SERVICE BULLETIN

Date: 12/15/2006 **Number:** SB0306

Subject: Partr # 533113 Hose (X-treme) is no longer available

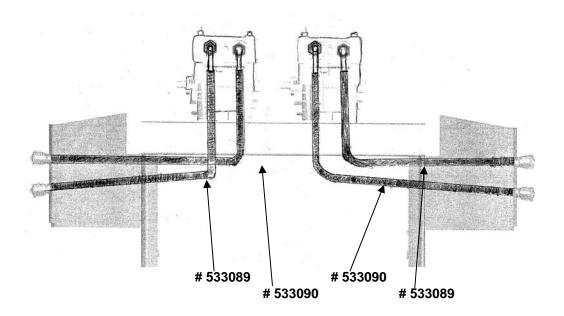
Details: When replacing Part # 533113 Hose you will need to order Part # 533090 Inside Line

(length 22.5") and Part # **533089** Outside Line (length 20.81"). Please make this change in your X-treme Parts Manuals.
